LAUREATE PARK COMMUNITY PARK AMENDMENT

SUMMARY

Revised Hartwell Court Cross-Section

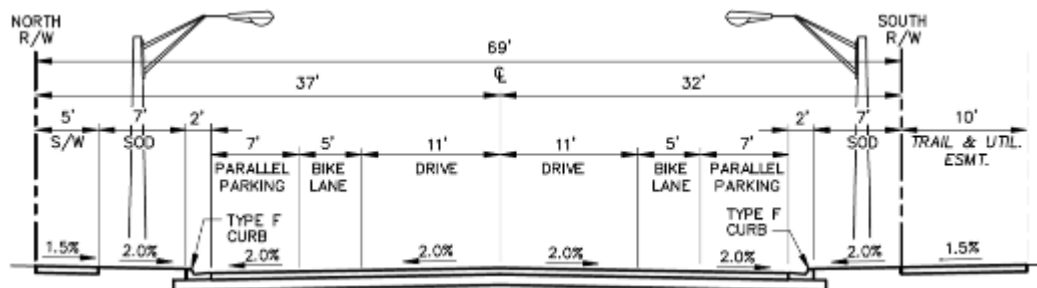
According to conditions outlined in MPL2016-00059 and SUB2016-00101, Hartwell Court should include a 10 ft. multiuse path, 7 ft. landscape buffer on each side, 9 ft. parallel parking with curb/gutter on each side, two 5 ft. bicycle lanes, two 11 ft. travel lanes, and a 5 ft. sidewalk for a combined cross section of 79 ft. (see the cross section below).

After further analysis, staff is revising the conditions for Hartwell Court to eliminate the two 5 ft. bicycle lanes and 5 ft. sidewalk and add two 12 ft. multiuse paths. In this specific context, the application of on-street bicycle lanes adds to the physical and perceived width of the street travel way without substantially improving bicycle safety and accessibility. By eliminating each bike lane, the curb-to-curb width of Hartwell Court narrows, contributing to traffic calming. In general, on-street bicycle lanes appeal to a relatively limited spectrum of bicycle riders, many of whom are likely to feel a comparable level of comfort sharing a travel lane with automobiles when speeds are slower. Off-street, multiuse pathways appeal to a broader range of bicycle riders and are substantially safer than on-street bicycle lanes, even when mixed with pedestrian traffic. Thus, the proposed cross section shown on page 16 is expected to benefit a greater number of local residents in their multimodal options. Moreover, this configuration is preferred for the anticipated extension of Hartwell Court into Poitras property, which will include over 3,500 single-family housing units.

Amended Site Plan

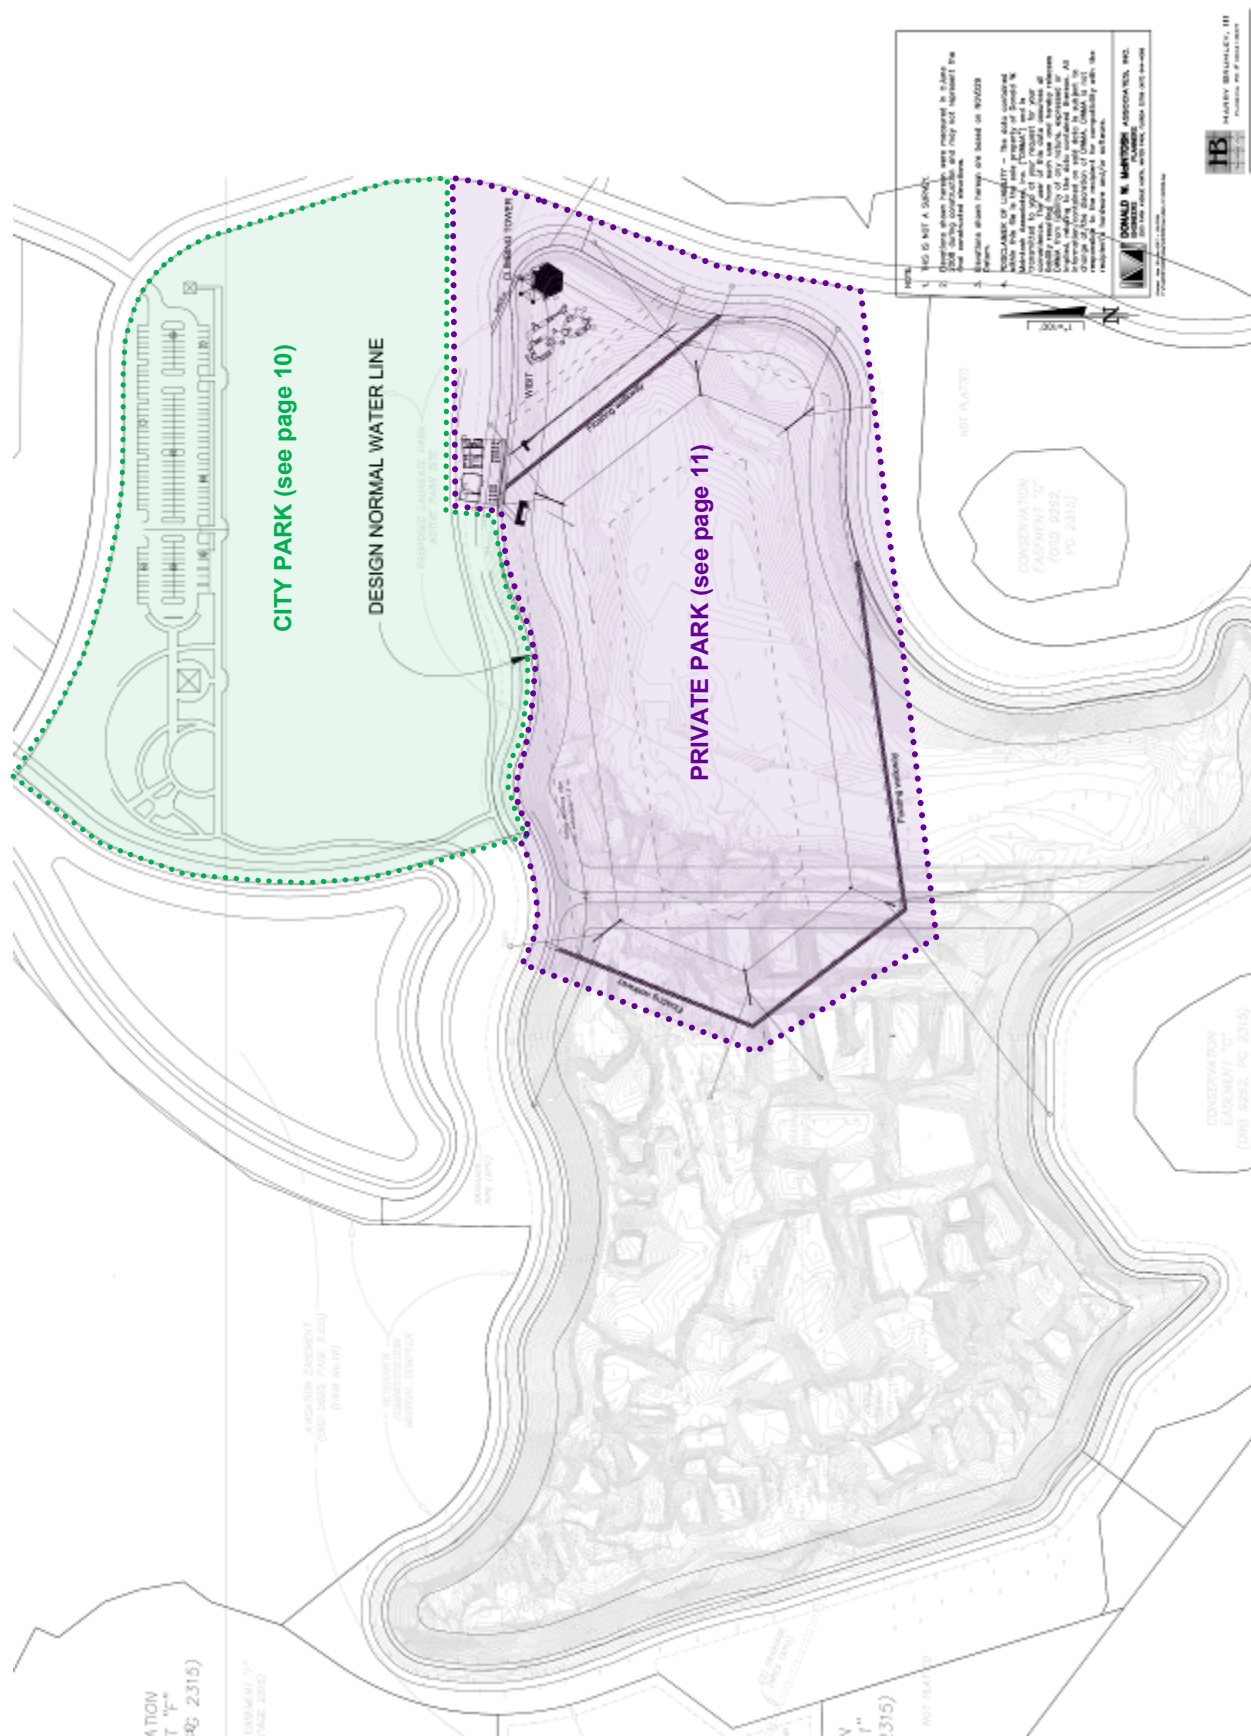
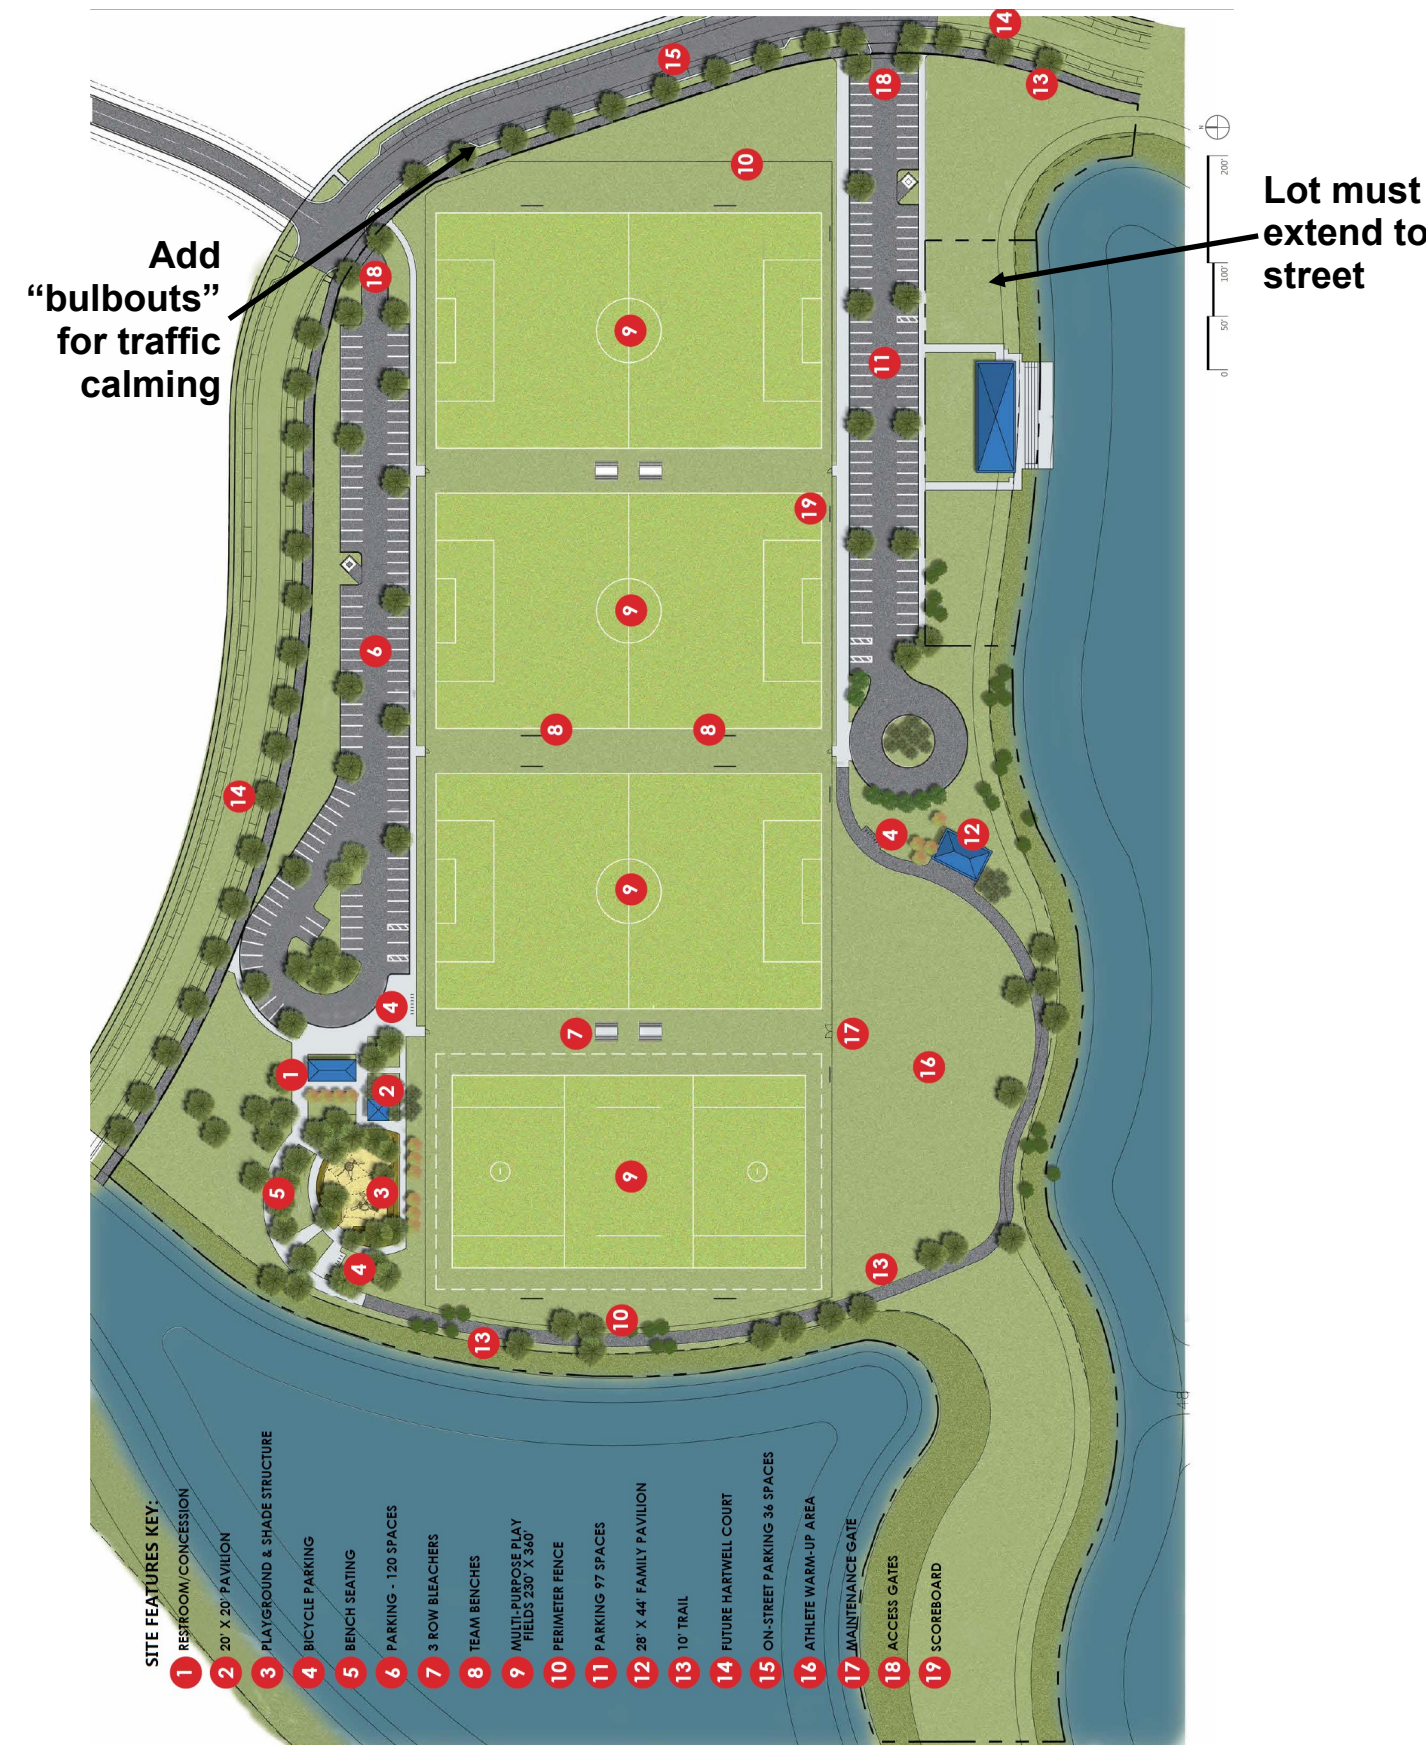
The proposed site plan shows 217 parking spaces. At least 180 parking spaces will be required for City park users; 40 spaces per field x 4 fields plus 20 spaces for park users who will use the paths, playground, etc. All parking spaces will be on property conveyed to the City. City of Orlando Family Parks and Recreation Department and Tavistock will enter into an agreement regarding the use of these parking spaces for the private park uses. It is expected that on-street parking spaces provided along Hartwell Court will adequately absorb overflow parking.

Hartwell Court includes on-street parking and the conditions of this report require that curb extensions (or bulbouts) are added, at a minimum, every 5 spaces, to define the on-street parking and provide traffic calming when the parking stalls are not in use. This requirement is based on LDC Section 61.312, specifying that landscaping areas are required every 10 parking spaces for parking lots. In this context, 5 parallel spaces is the equivalent separation distance as 10 perpendicular spaces (approximately 100 feet).

The amended site plan shows two buildings additional—each approximately 1,500 sq. ft. in area—intended for pro-shop retail, equipment rental, bathrooms, and some eating & drinking. The plan also shows café seating between the buildings and mean waterline.
